MEMORANDUM

SUBJECT: Addendum to Integrated Discharge Permit Application for the Black Butte
Copper Project

ATTACHMENT A
REVISED FIGURES

FIGURE 1.3
Facilities Site Plan
Black Butte Copper Project
Mine Operating Permit Application
 Meagher County, Montana

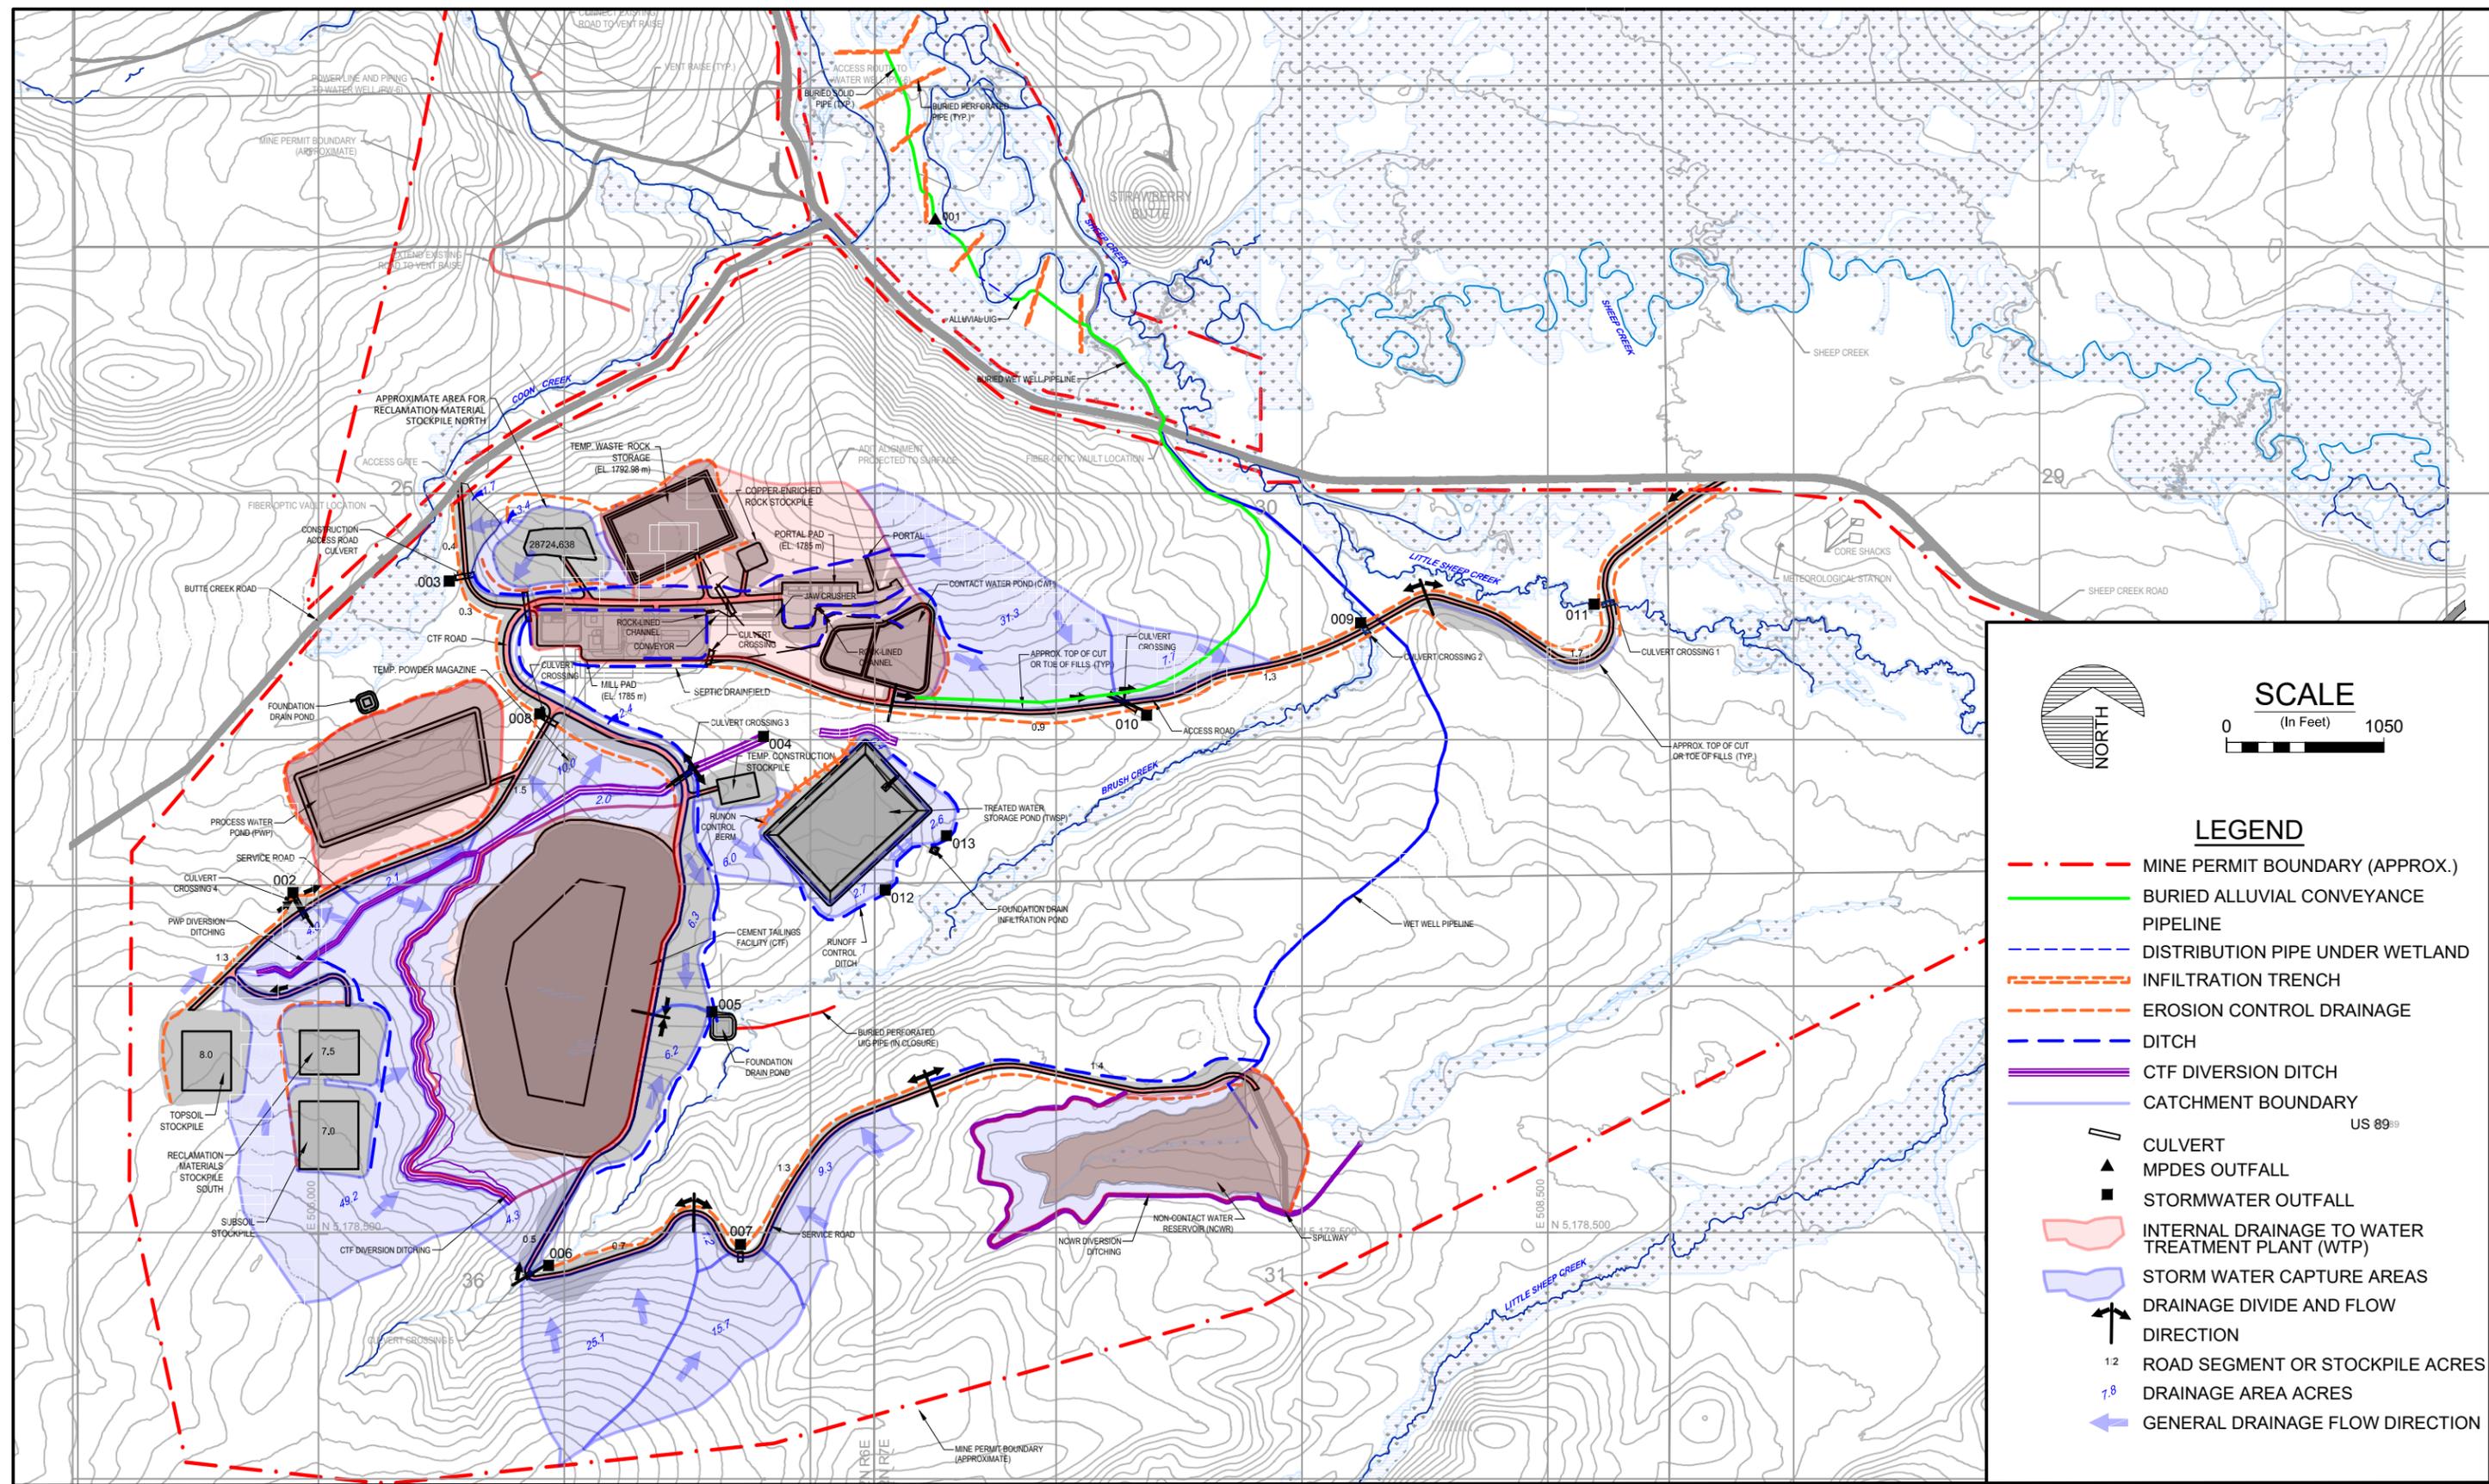
The TWSP will be located southeast of the WTP and west of Brush Creek as shown the revised Figure 1.3 included in Attachment 1. The design of the TWSP was based on an average seasonal flow rate from the WTP of 405 gpm. The average seasonal flow rate is slightly larger than the average annual discharge due to minor differences in seasonal flows from Mill Catchment Runoff associated with the seasonal precipitation and evaporation at the site. The TWSP has been designed to store up to 53.7 million gallons of treated water, providing enough temporary storage for treated water from July 1 to September 30 at an average flow rate of 405 gpm. The pond will be lined with a 60 mil HDPE geomembrane liner installed over a 12 oz/yd² non-woven geotextile cushion. Treated water from the water treatment plant will be pumped through a 6-inch (150mm) diameter HDPE pipeline to the TWSP. Water stored in the TWSP will then be pumped back to the water treatment plant via a 6-inch (150mm) diameter HDPE pipeline, where it will be mixed with the WTP effluent and allow for the blended water to be sampled prior to being discharged per the MPDES permit.

Figure 3.1
MPDES and Storm Water Discharge Systems
 Black Butte Copper Project
 Meagher County, Montana

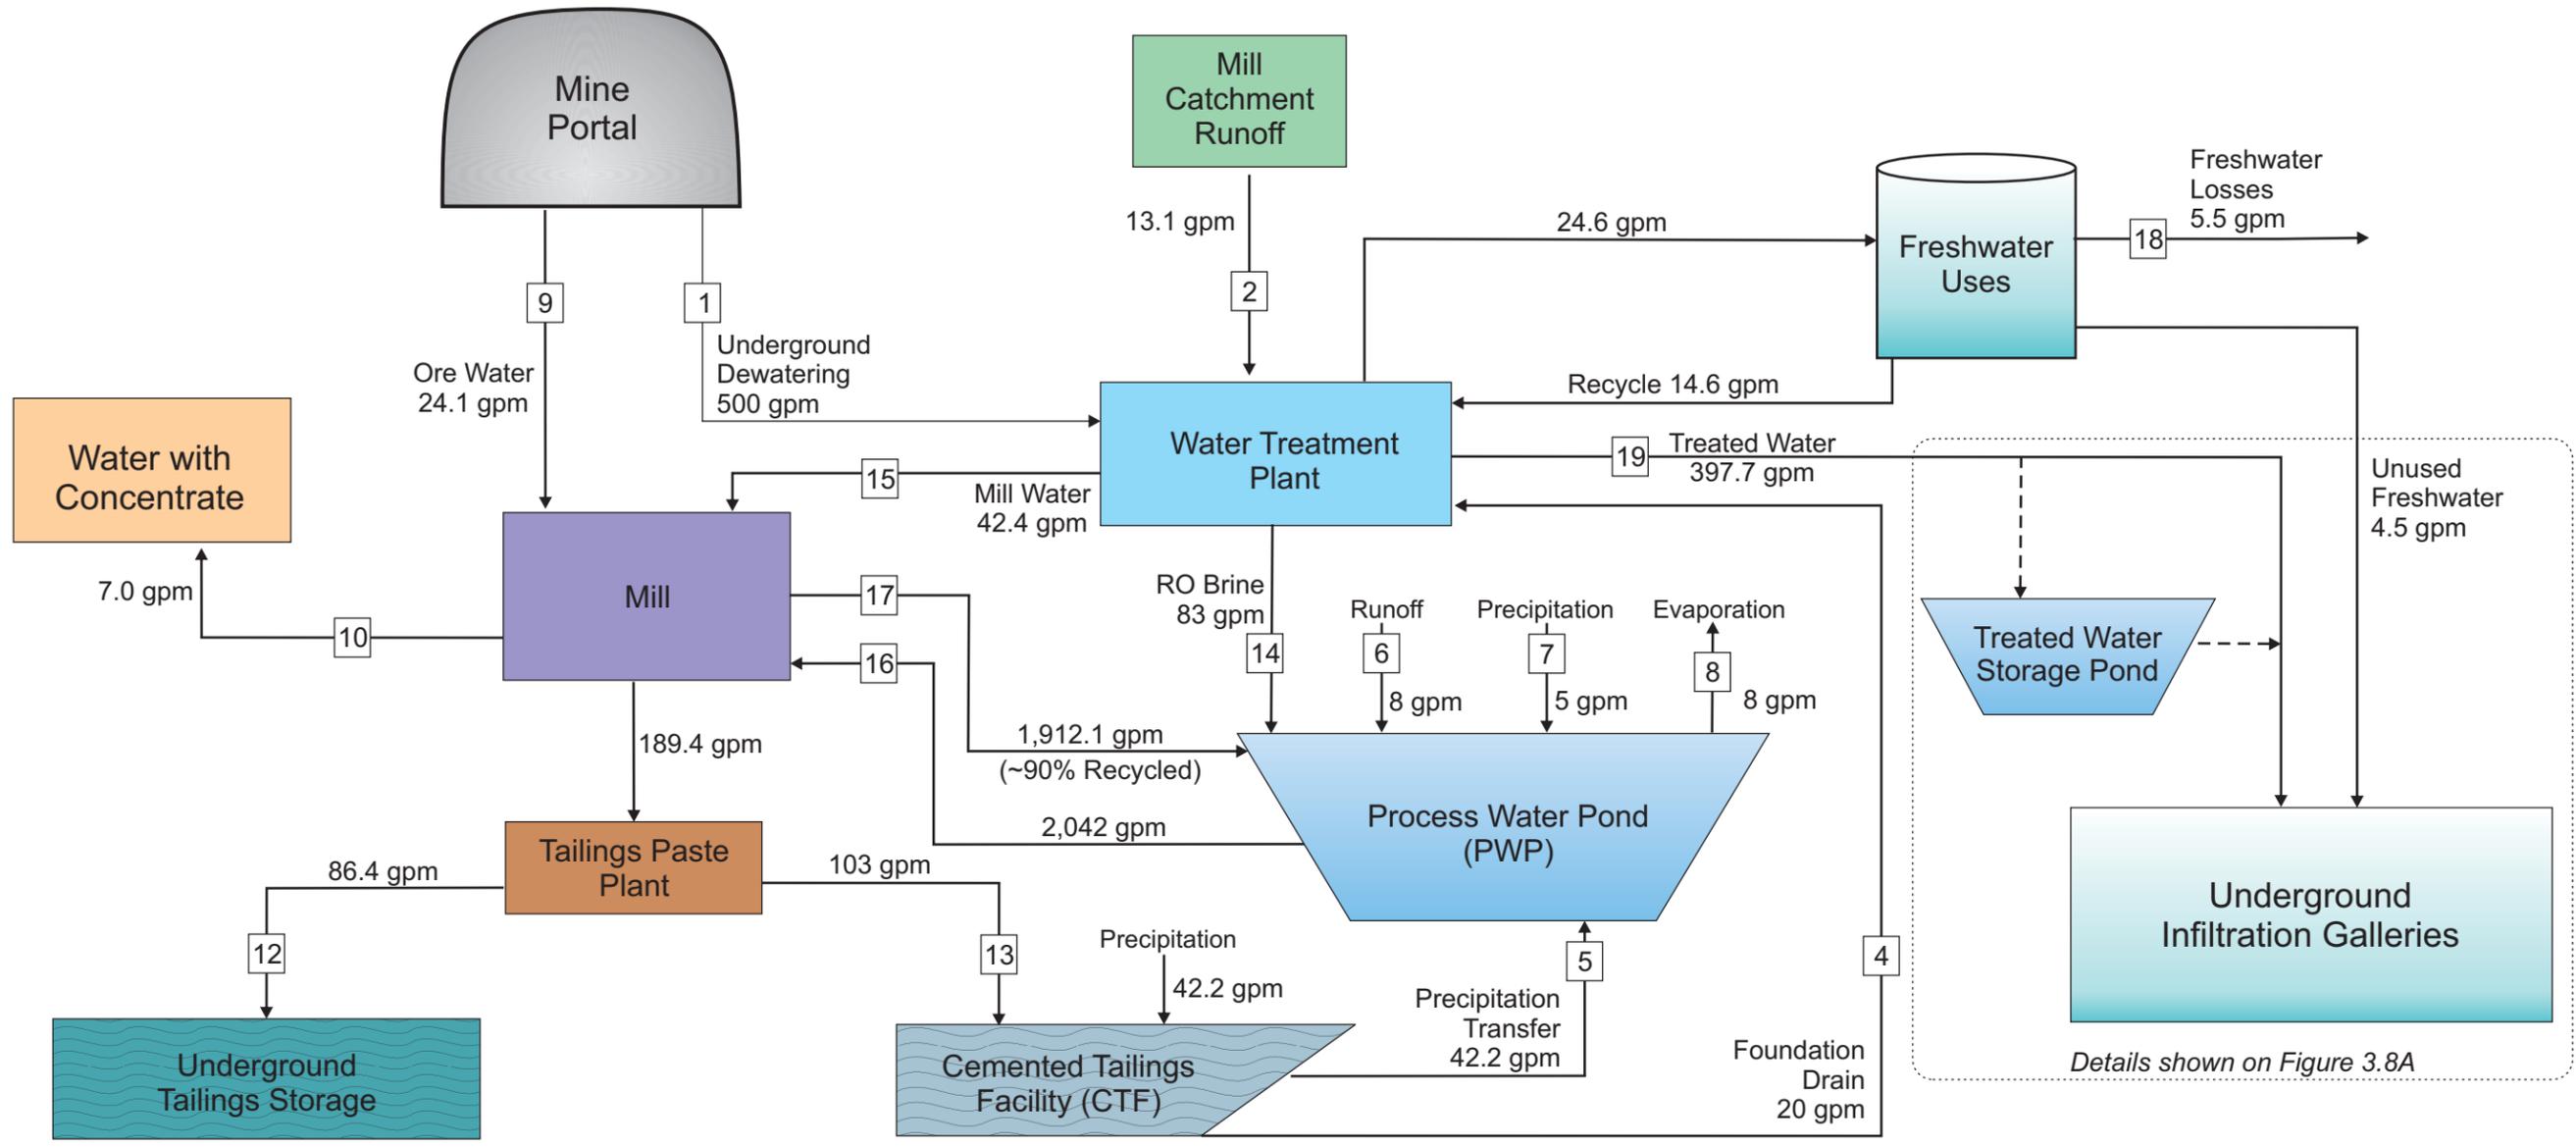
The addition of the TWSP requires updates to the site drainage controls and storm water permit. The additional storm water controls include a runoff control berm on the northwest portion of the pond, drainage ditches along the remainder of the facility, and two storm water outfalls (Outfalls 012 and 013). An update to Figure 3.1 shows the storm water controls and outfalls for the project. Storm water flows to each of the new outfalls were simulated using the same methods and modeling software for the other outfalls (See Section 4.2 of permit). In addition, storm water quality is assumed to be similar to that summarized in Section 4.3 of the permit. Below is a description of the new drainage controls and a summary of the changes to the permit application.

A revised Site Drainage Map (Figure 3.1) is included with this memorandum

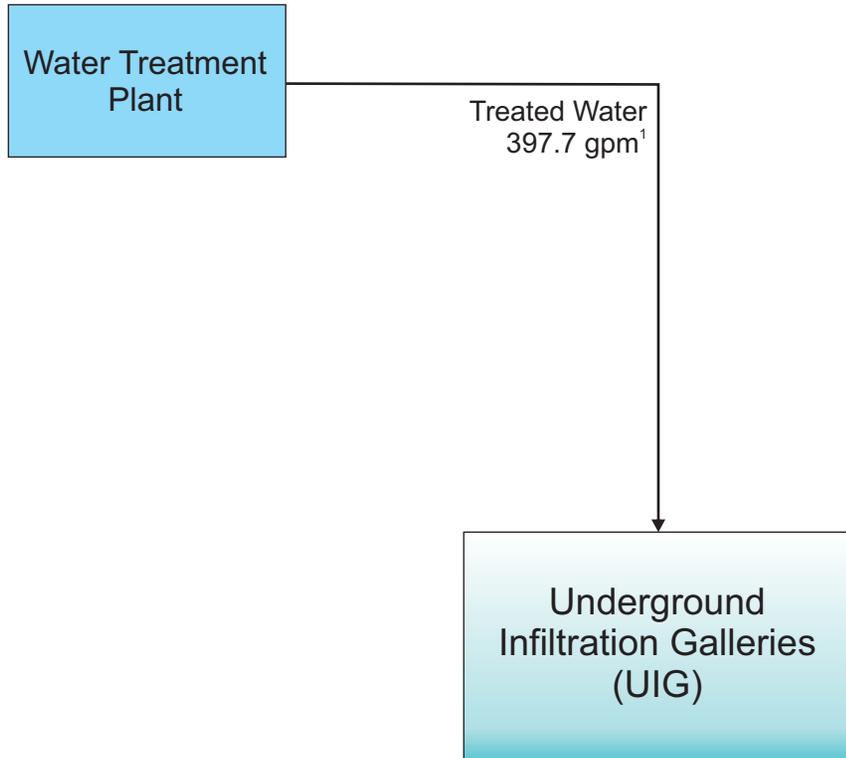
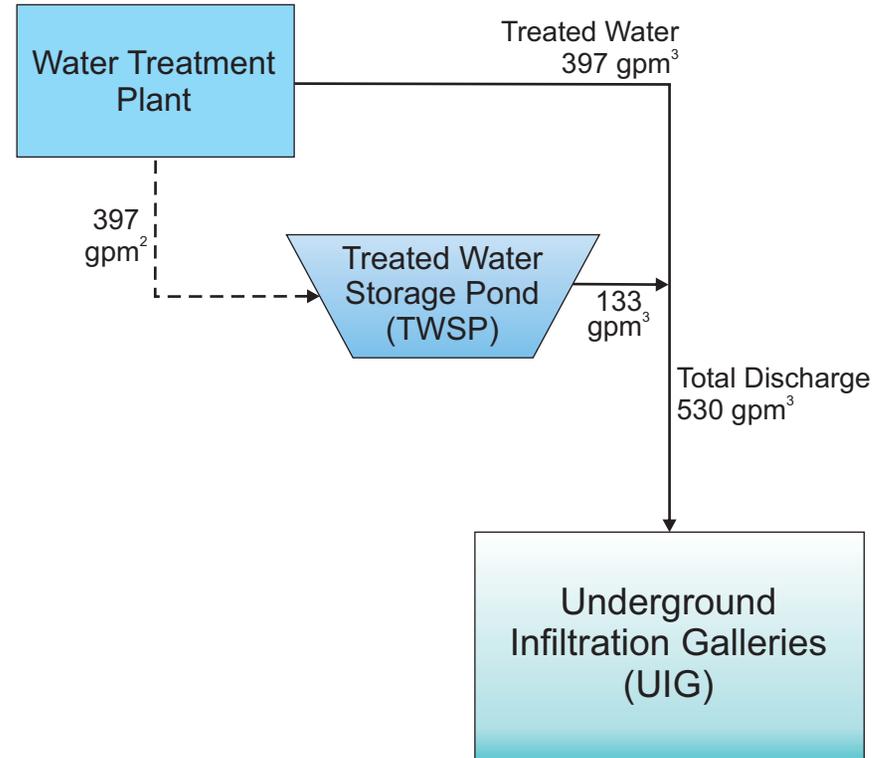
Tintina is proposing to discharge water as described in the Integrated Discharge Permit Application Narrative (Hydrometrics, 2018) if the discharge water meets the seasonal effluent limits for total nitrogen in the MPDES permit. However, if the total nitrogen concentration is greater than the effluent limit, the treated water will be discharged to the Treated Water Storage Pond (TWSP) from July 1st to September 30th. Starting October 1st, the stored water will be routed back to the WTP and blended with the WTP effluent prior to discharge to Outfall 001. Prior to discharge the blended water will be sampled/monitored as required in the MPDES permit. In the event that storage is necessary, the average seasonal discharge (October 1st to June 30th) to Outfall 001 will be 531 gpm (133 gpm from the TWSP and 398 gpm from the WTP). An updated water balance schematic (revised Figure 3.8) and contingency discharge schematic (Figure 3.8A) is provided in Attachment A.

1. If effluent total nitrogen concentration is < seasonal effluent limit water will be discharged to UIG continuously.
2. If effluent total nitrogen concentration is > seasonal effluent limit water will be stored in TWSP from 7/1 to 9/30.
3. Water will be discharged from TWSP by blending water with WTP effluent at an average rate of 530 gpm.
